**Land at Rowley Lane, Lepton
Proposed Residential Land Allocation
Transport Addendum**

December 2016 (Revision 1)

Prepared on behalf of
Redrow Homes Yorkshire/Portman Land Limited

Appendix A Masterplan

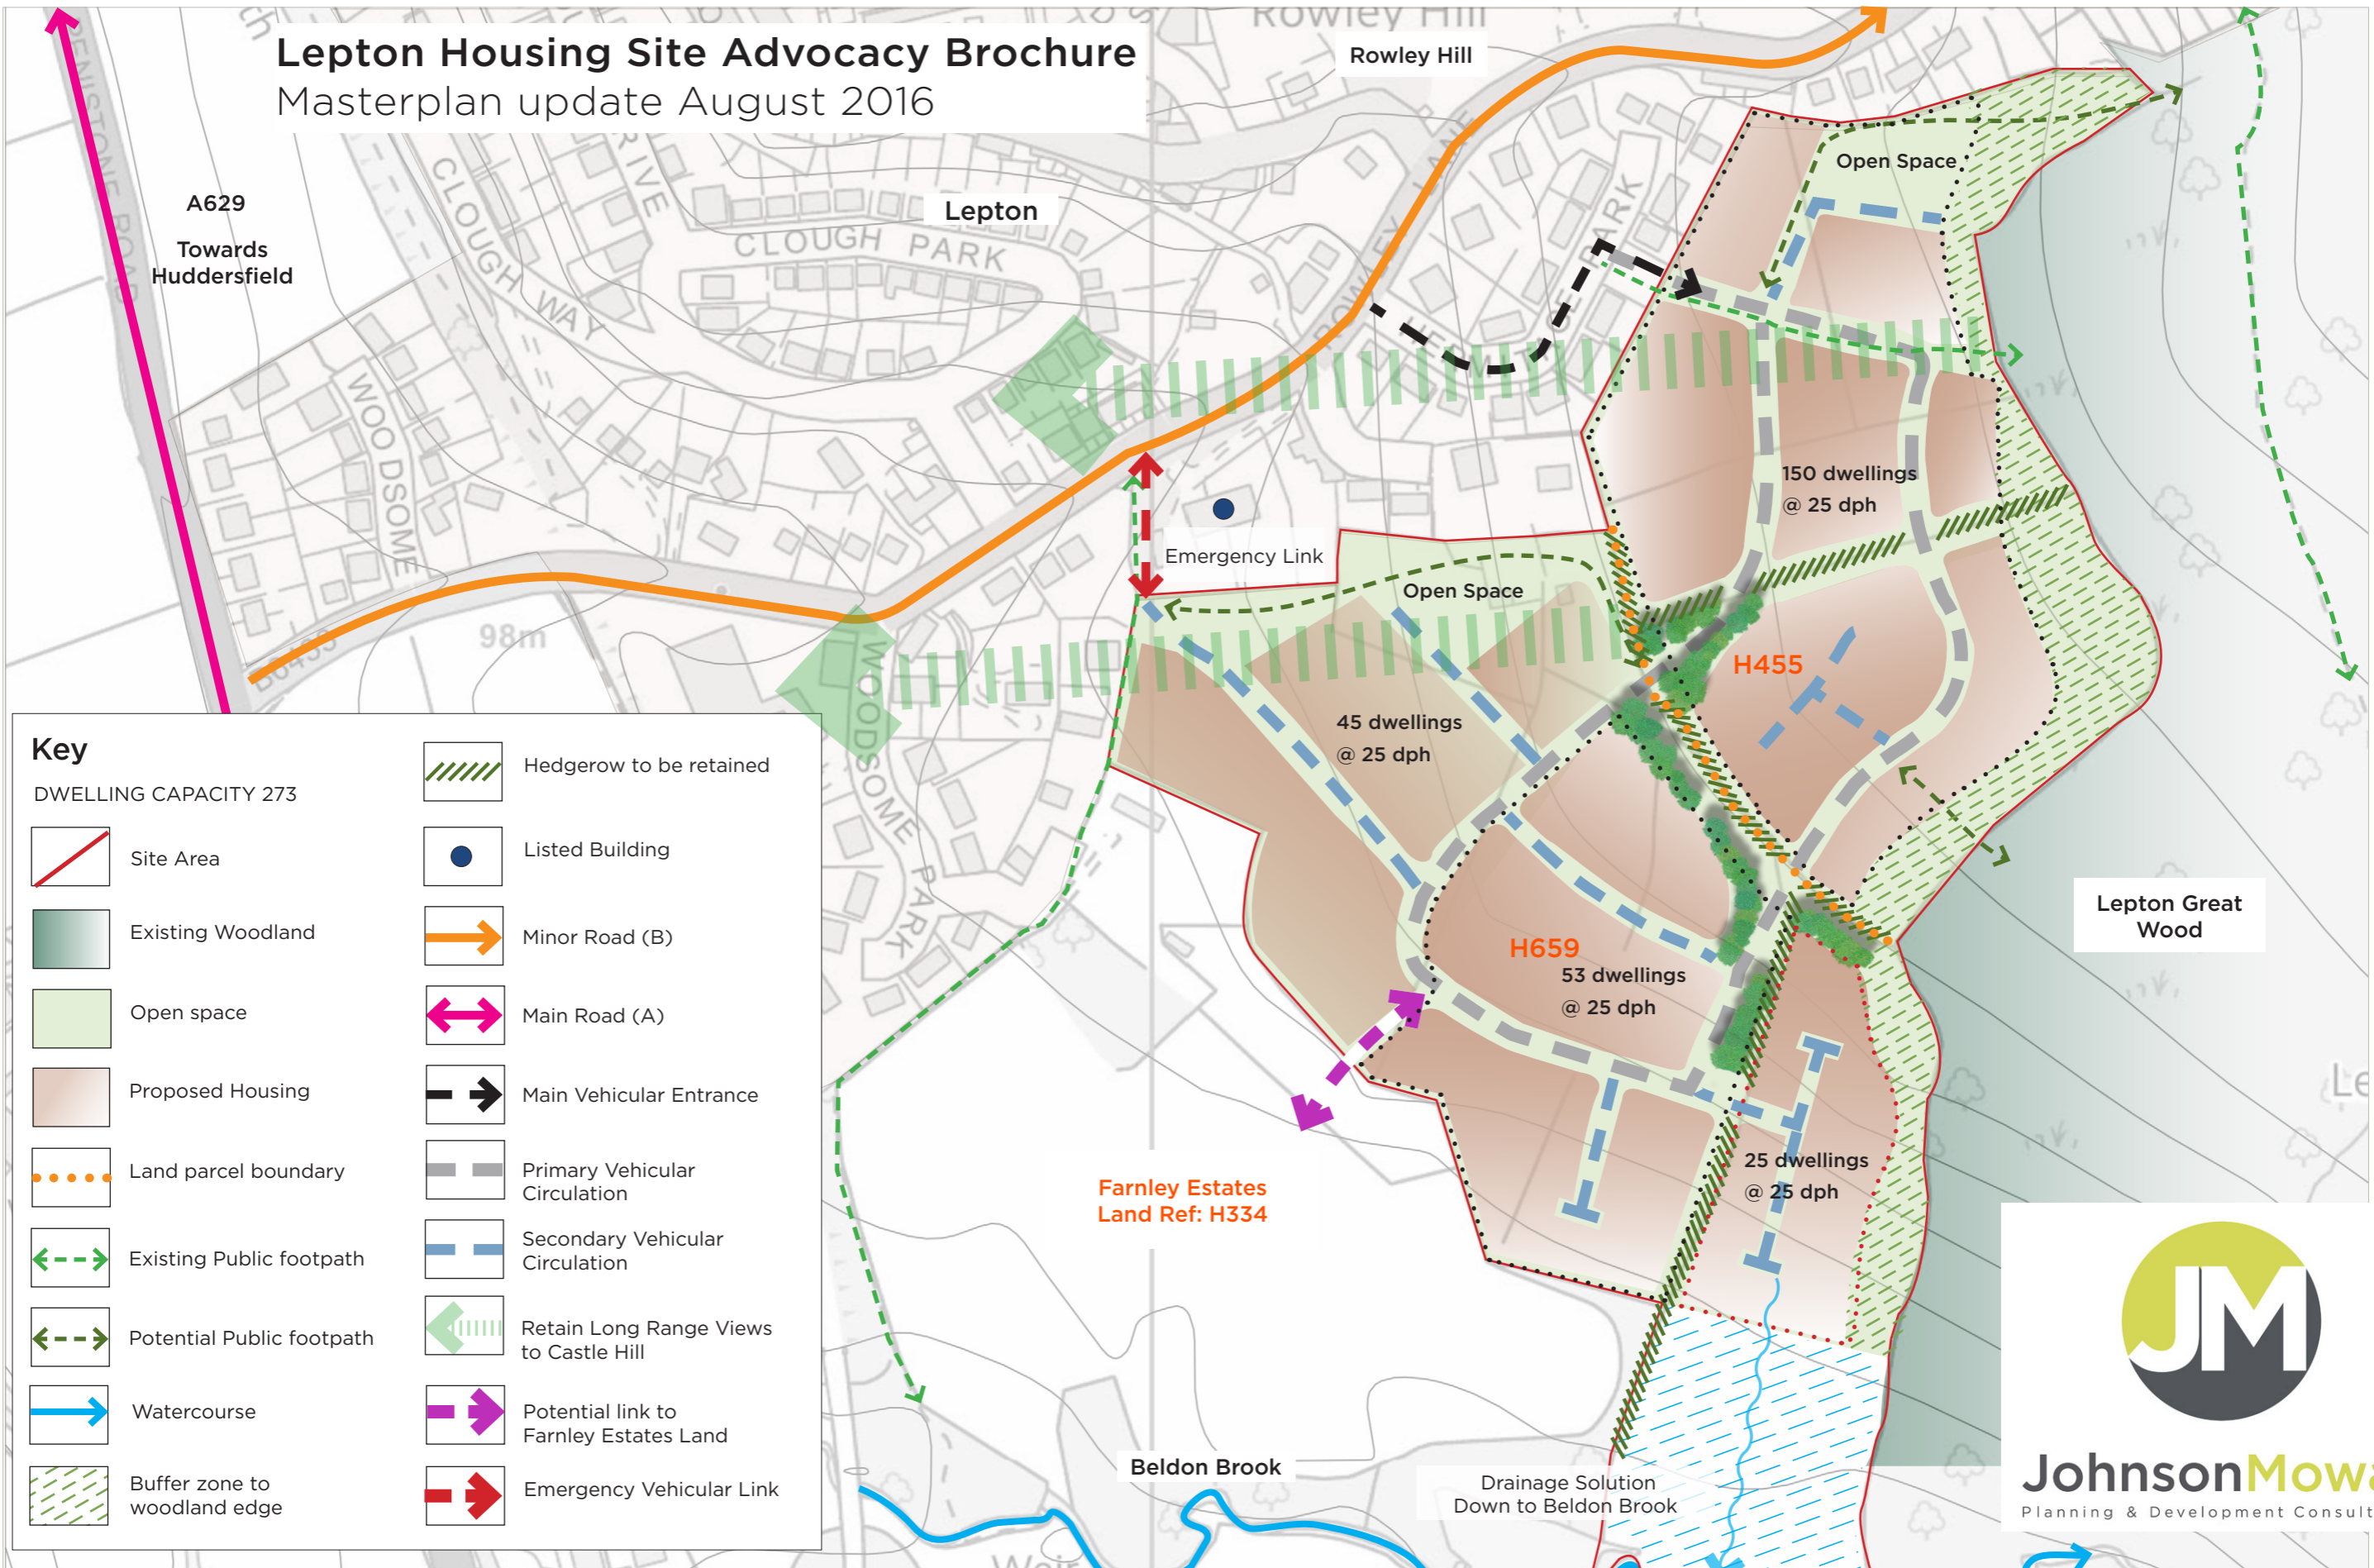
3.1.2 No illustrative masterplan indicating 300 dwellings has been provided.

An illustrative schematic masterplan was previously included at Appendix C of the Access Appraisal. This has been updated and is included in this Addendum at Appendix A.

PROJECT	ROWLEY LANE, LEPTON
DRAWING TITLE	LOCATION OF SPEED SURVEYS ON ROWLEY LANE

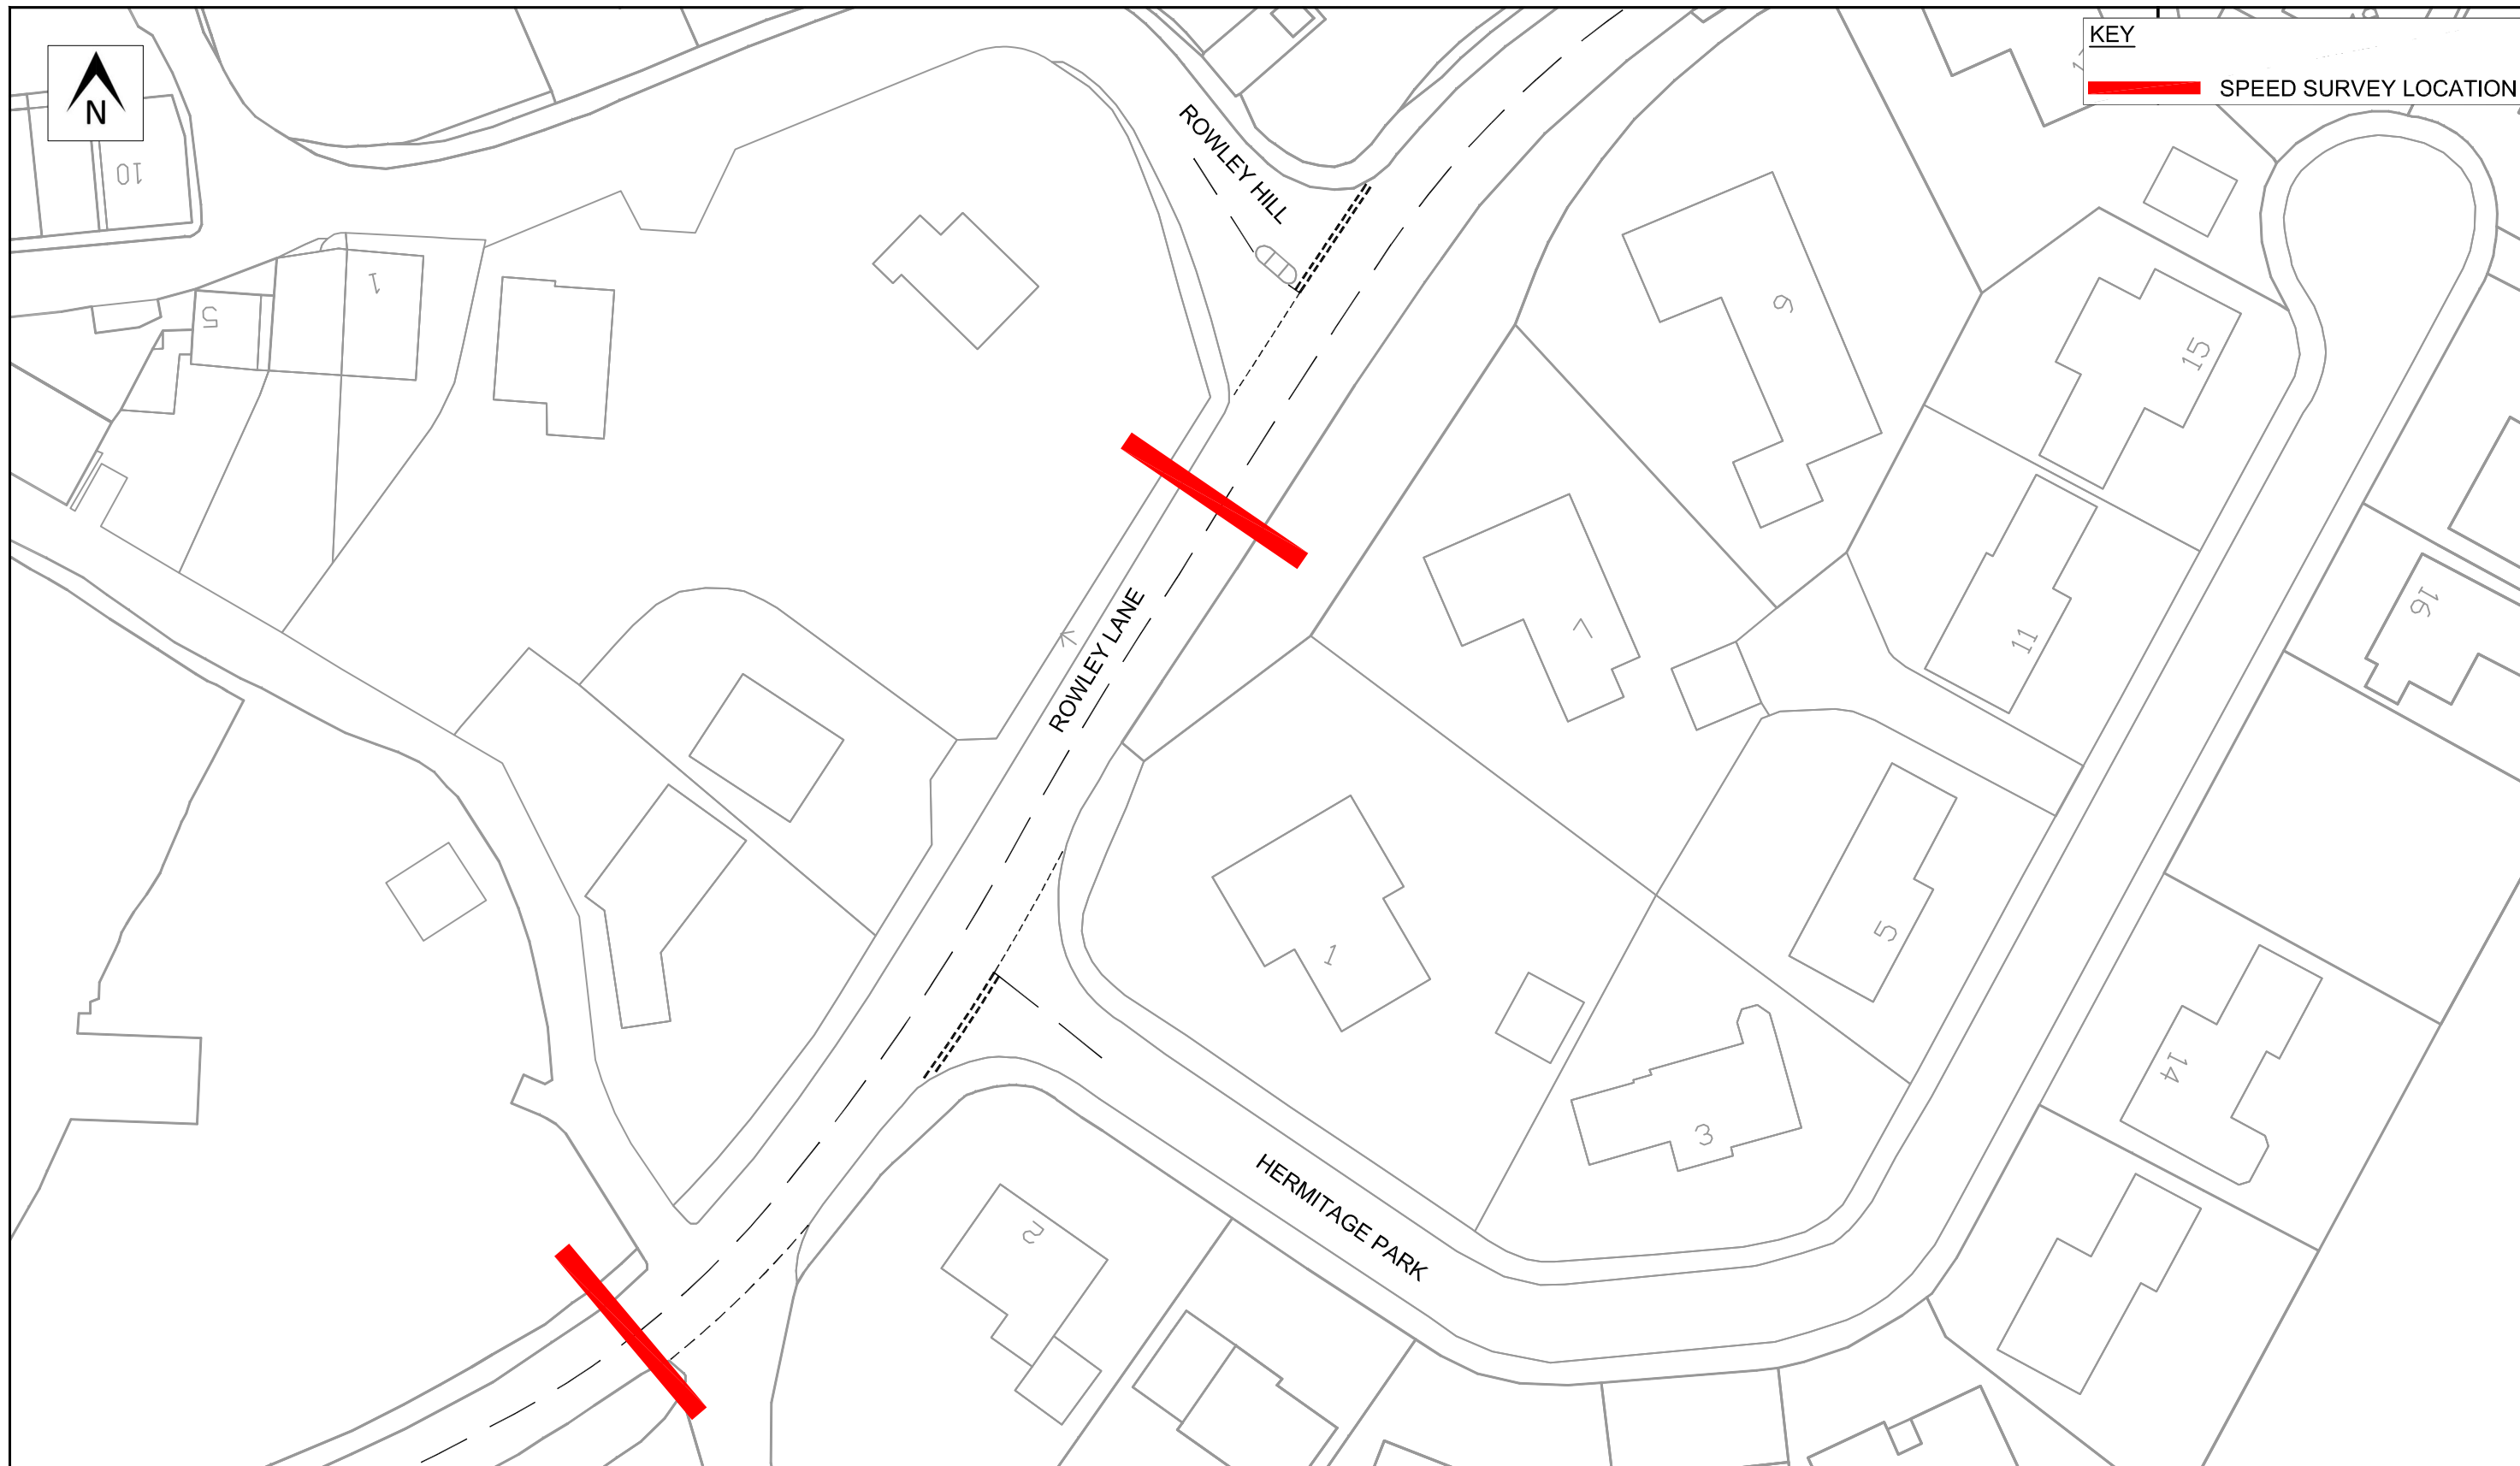
2.3.2 To enable HDM to be satisfied with the submitted speed readings, a plan is required detailing the locations along Rowley Lane where the data was captured.

Drawing IN/03 Rev A attached at Appendix D shows the locations of the speed surveys recording vehicles as they approached the Hermitage Park junction.

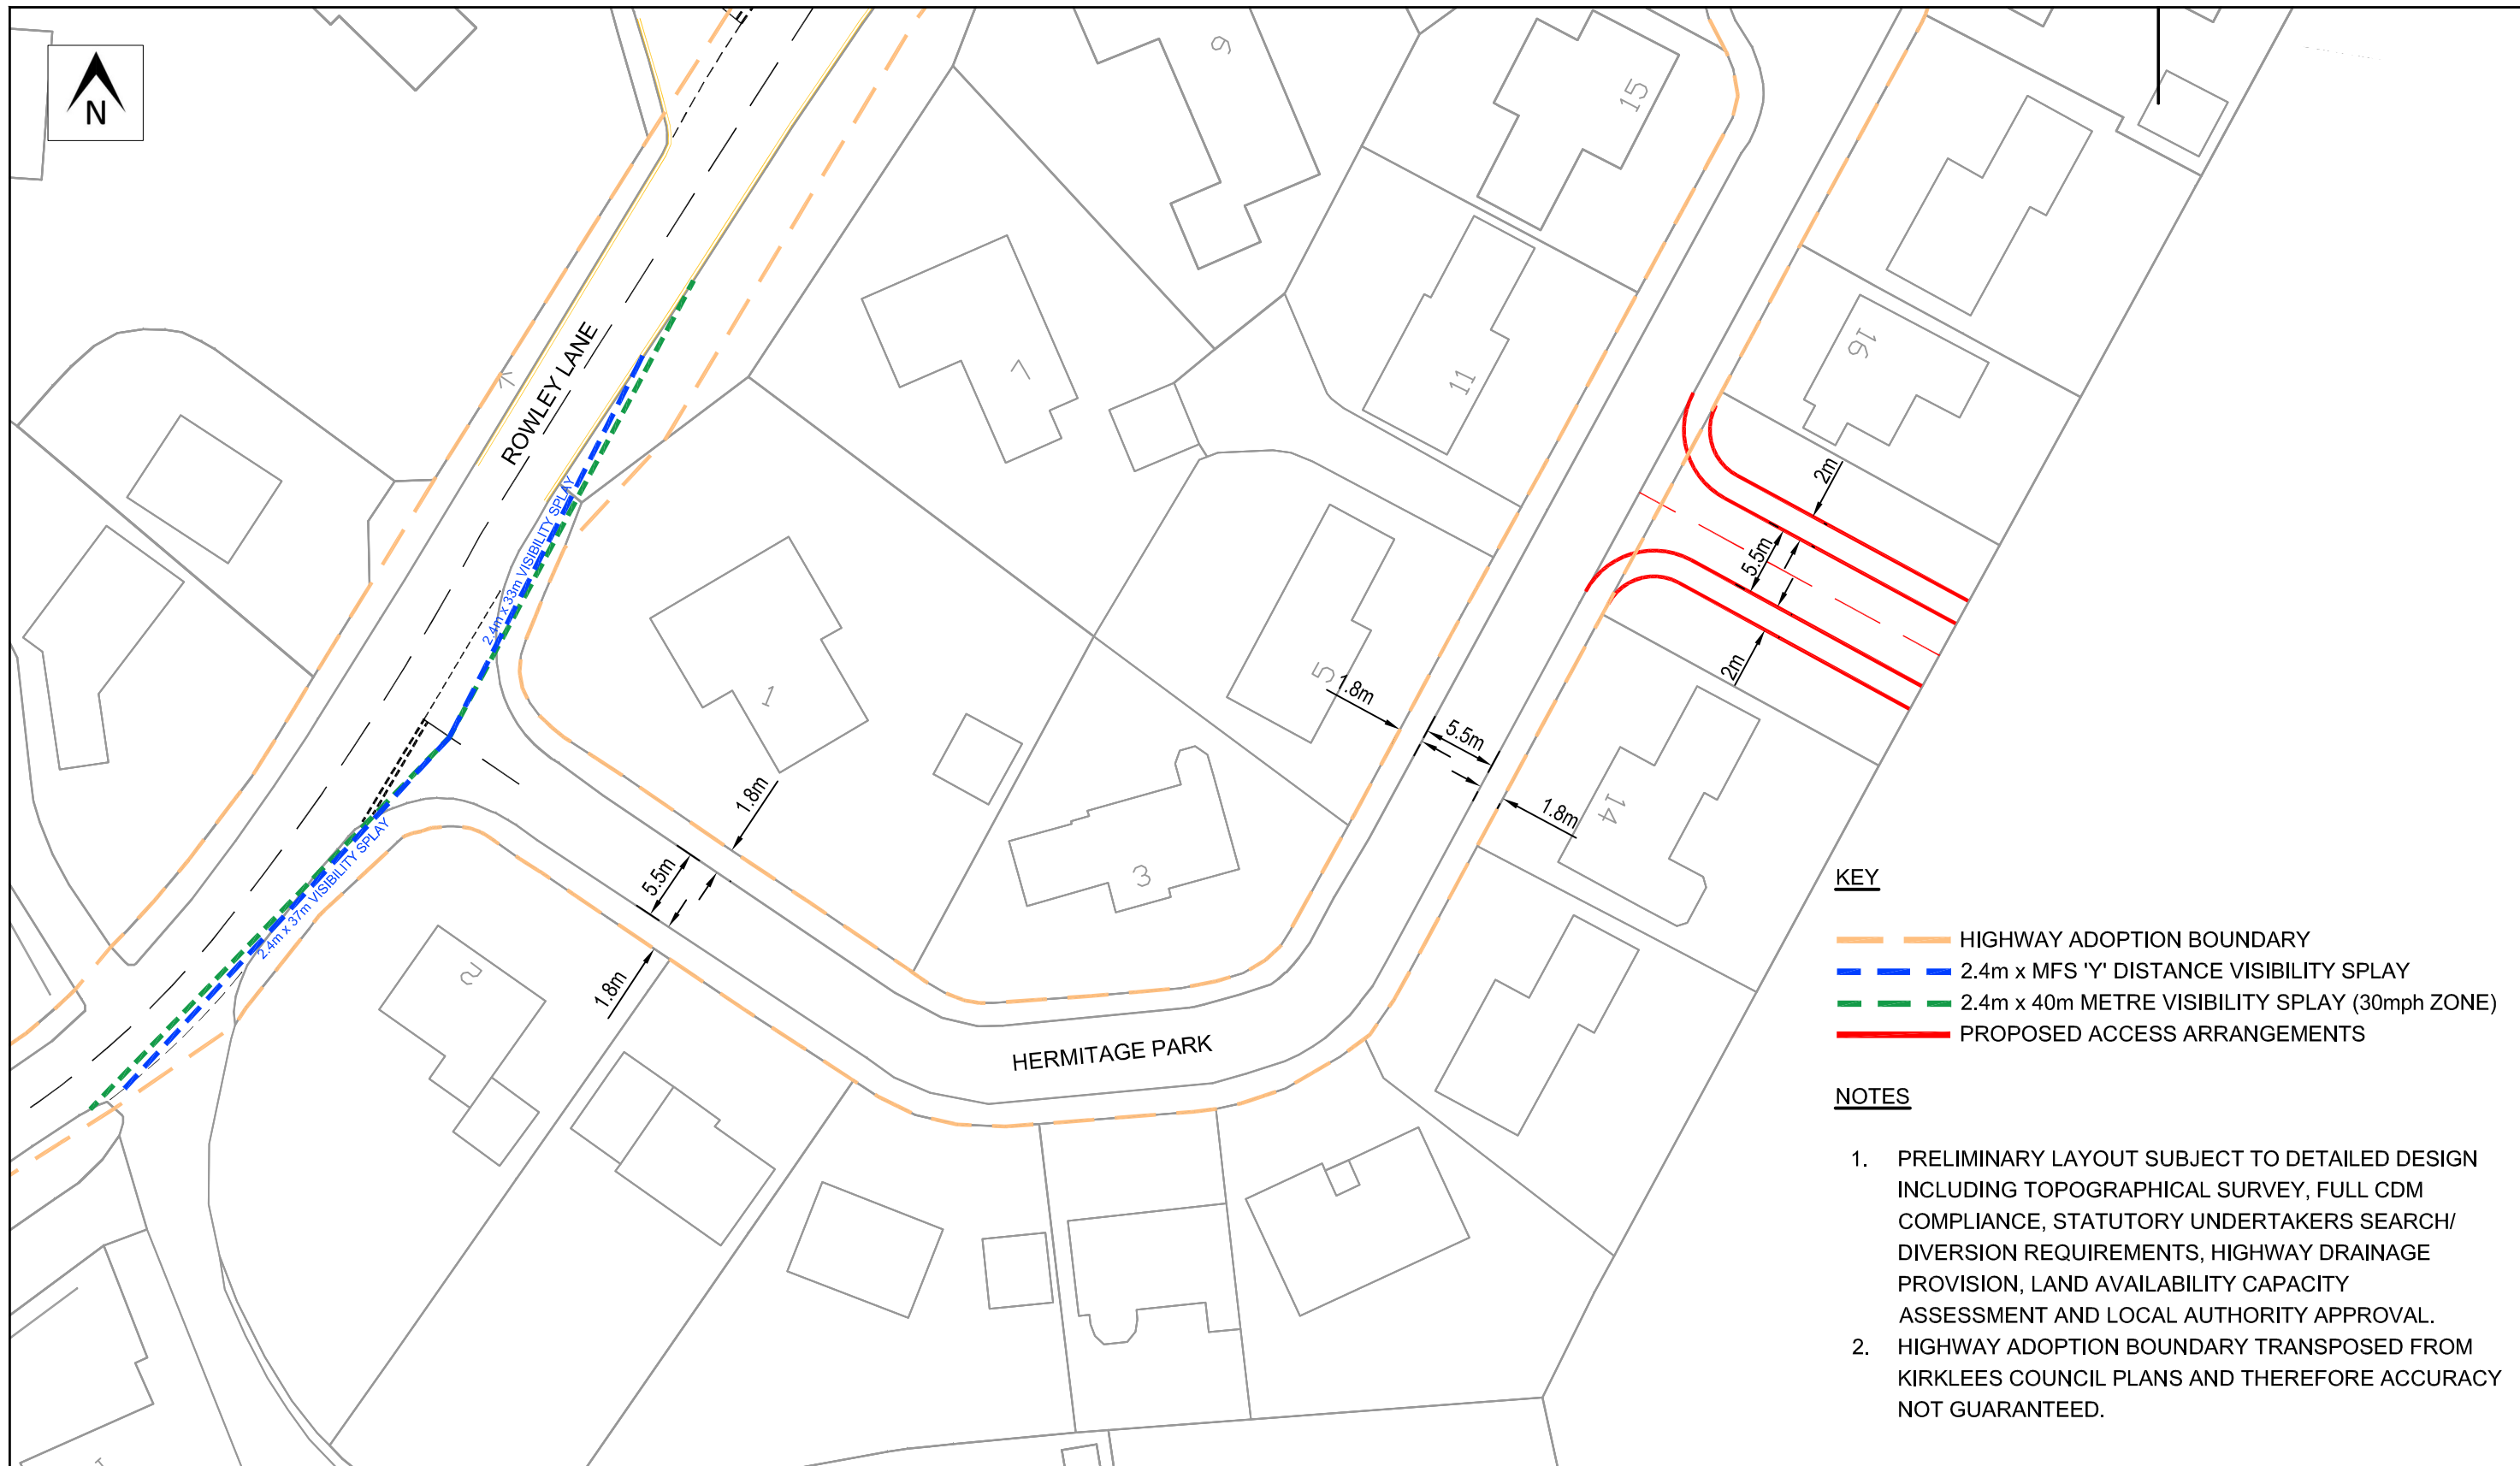
Para 5.1.2: Notwithstanding the submitted speed readings which require qualifying as per the HDM comment above (para 2.3.1), the recorded southwest 28mph reading would require a 'Y' visibility distance of 44.0m, contrary to the 33.0 detailed on plan ref: 13015/N/02.

In addition, a plan is also required demonstrating 25.0m driver forward visibility around the junction radii travelling into Hermitage Park from the northeast.
